PROPOSED CHANGES TO THE
GRAND GULF NUCLEAR STATION
TECHNICAL SPECIFICATIONS

NRC TECHNICAL REVIEW BRANCH: ACCIDENT EVALUATION

PROPOSED CHANGES TO THE
GRAND GULF NUCLEAR STATION
TECHNICAL SPECIFICATIONS

NRC TECHNICAL REVIEW BRANCH: MATERIALS ENGINEERING

Figure 3.4.6.1-1

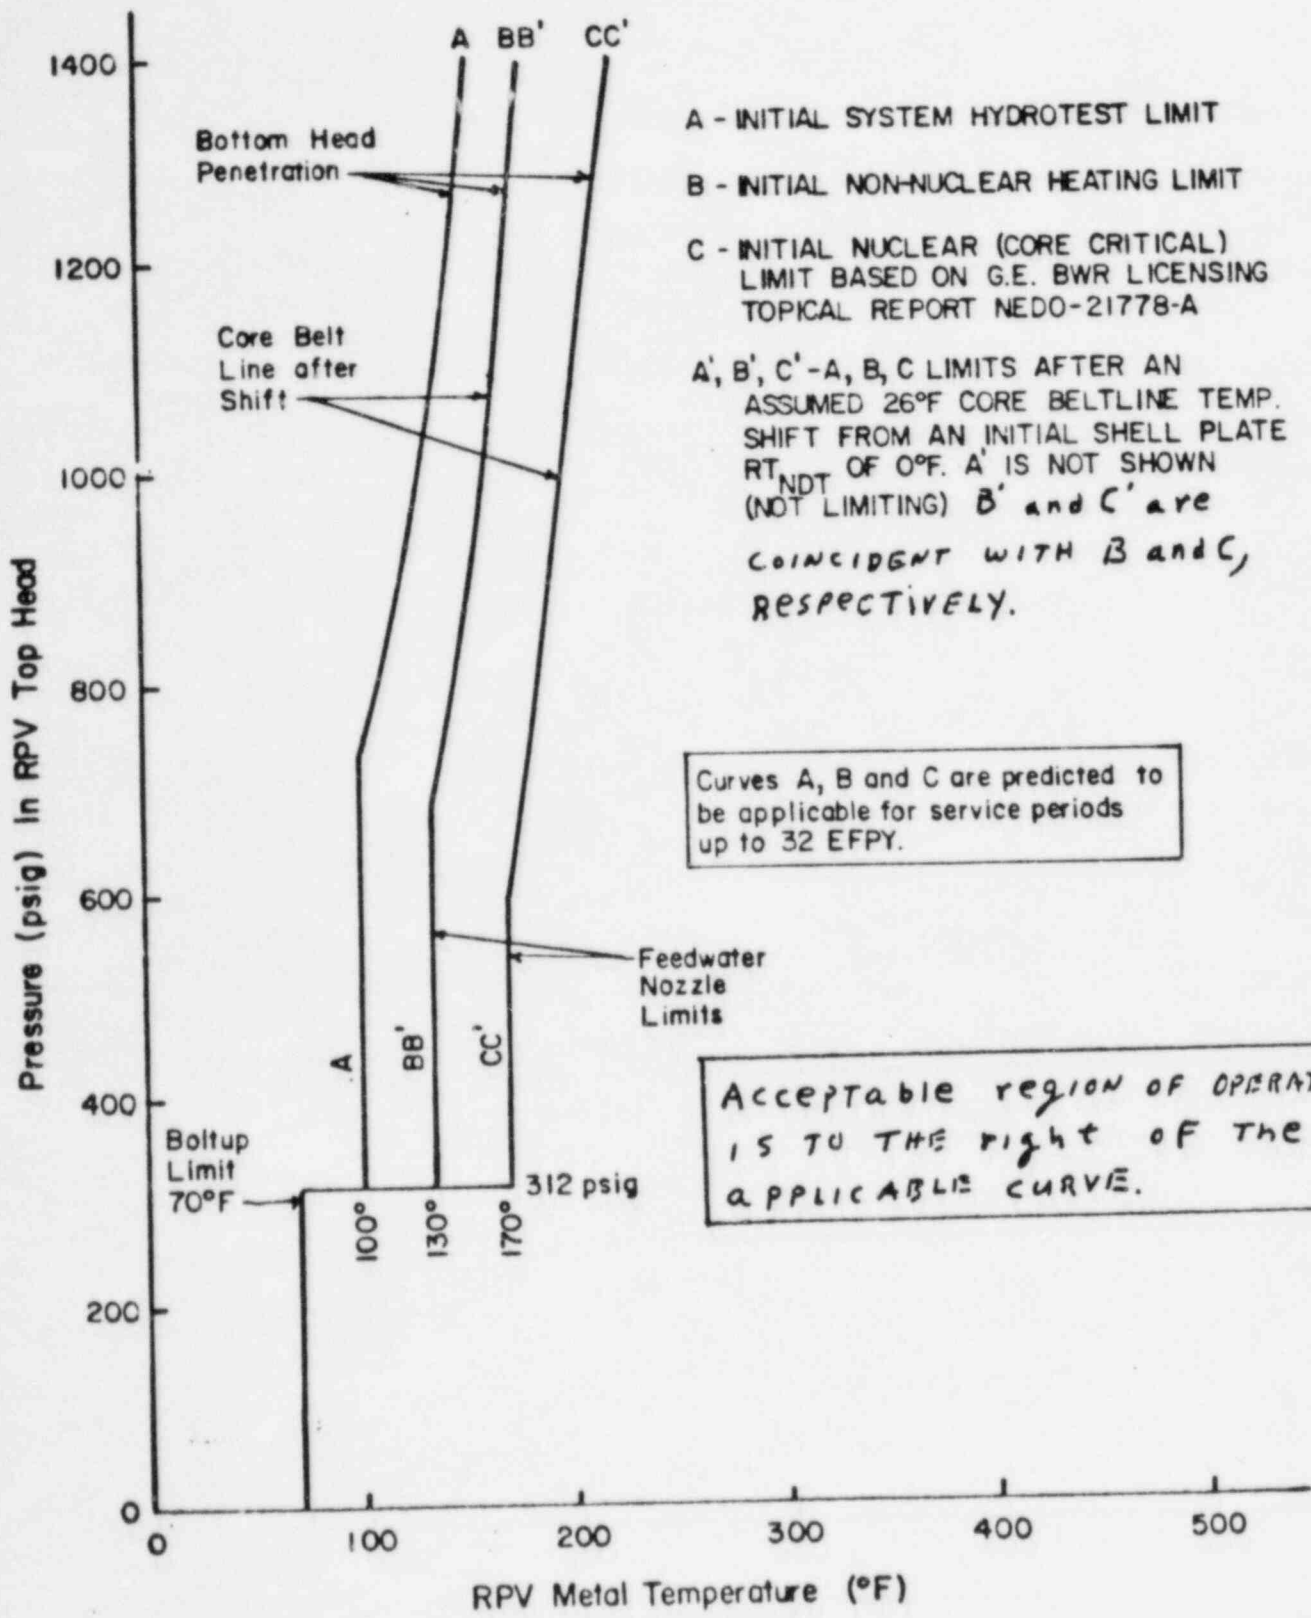
The proposed change to this specification is to clarify that reactor vessel metal temperature rather than reactor coolant system temperature is to be used in conjunction with Figure 3.4.6.1-1. This will make the specification consistent with the figure which is based on vessel metal temperature. The specification is further revised to refer specifically to reactor coolant temperature for the maximum heatup/cooldown rates. This is conservative, since the coolant temperature will change more rapidly than the vessel metal temperature. Additionally, it is proposed to revise Surveillance Requirement 4.4.6.1.3 to indicate that reactor vessel material specimens will be removed and examined in accordance with Appendix H of 10 CFR 50 and to renumber Surveillance Requirements 4.4.6.1.3 and 4.4.6.1.4 so that requirements dealing with temperature measurement and requirements dealing with materials testing are grouped together appropriately. This proposed change also adds Specification 4.4.6.1.5 to require removal and examination of the reactor flux wire specimens during the first refueling outage for determination of pressure vessel fluence as a function of time and power level. This is consistent with current industry practice, since flux wires contain fewer impurities than material specimens and therefore provide a more accurate indication of neutron fluence. Also, for further clarification, Figure 3.4.6.1-1 is revised to indicate that

the region of acceptable operation is to the right of the curves and that B' and C' are coincident with B and C, respectively. Bases 3/4.4.6 is also revised to maintain consistency with the proposed change and to clarify that the revised figure complies with 10 CFR 50, Appendix G. This proposed revision provides consistency with GGNS FSAR Section 5.3.2.1. This change improves the safety of the plant by clarifying certain requirements, assuring conformance with current regulations, and assuring consistency with the plant as described in the safety analyses. (Pages 3/4 4-17, 3/4 4-18, 3/4 4-19, B 3/4 4-4, and B 3/4 4-5)

This proposed change revises the curves of Figure 3.4.6.1-1 to conform to the revised requirements of 10CFR50, Appendix G, paragraph IV.A.2 and 3, (May, 1983); also, a statement is added to Bases 3/4.4.6 to indicate that the RT_{NDT} for welds and base material in the closure region is equal to or less than $10^{\circ}F$ and that the initial hydrostatic test pressure was 1563 psig. The curves presently in the technical specifications conform with the requirements of the previous revision of Appendix G, with the exceptions noted in GE BWR Licensing Topical Report NEDO-21778-A. The proposed curves are in compliance with the revised Appendix G requirements to maintain the appropriate margins (as defined in the revised IV.A.2) above the bolt-up reference temperature at pressures exceeding 20 percent of the preservice system hydrostatic test pressure. For pressures below 20 percent of the preservice hydrostatic test pressure, the proposed curves meet the requirement to maintain a $60^{\circ}F$ margin above the bolt-up reference temperature, as defined in paragraph IV.A.3. It is therefore concluded that this change is in compliance with 10CFR50, Appendix G requirements and is in accordance with recent NRC guidance to implement the May, 1983 revisions to Appendix G in the Grand Gulf Technical Specifications. (Page 3/4 4-19 and B 3/4 4-4)

The reactor vessel materials have been tested to determine their initial RT_{NDT} . The results of these tests are shown in Table B 3/4.4.6-1. Reactor operation and resultant fast neutron, E greater than 1 Mev, irradiation will cause an increase in the RT_{NDT} . Therefore, an adjusted reference temperature, based upon the fluence, phosphorus content and copper content of the material in question, can be predicted using Bases Figure B 3/4.4.6-1 and the recommendations of Regulatory Guide 1.99, Revision 1, "Effects of Residual Elements on Predicted Radiation Damage to Reactor Vessel Materials." The pressure/temperature limit curve, Figure 3.4.6.1-1, curves A', B' and C', includes predicted adjustments for this shift in RT_{NDT} for the end of life fluence as well as adjustments for possible errors in the pressure and temperature sensing instruments. *Curves B' and C' are coincident with curves B and C, respectively.*
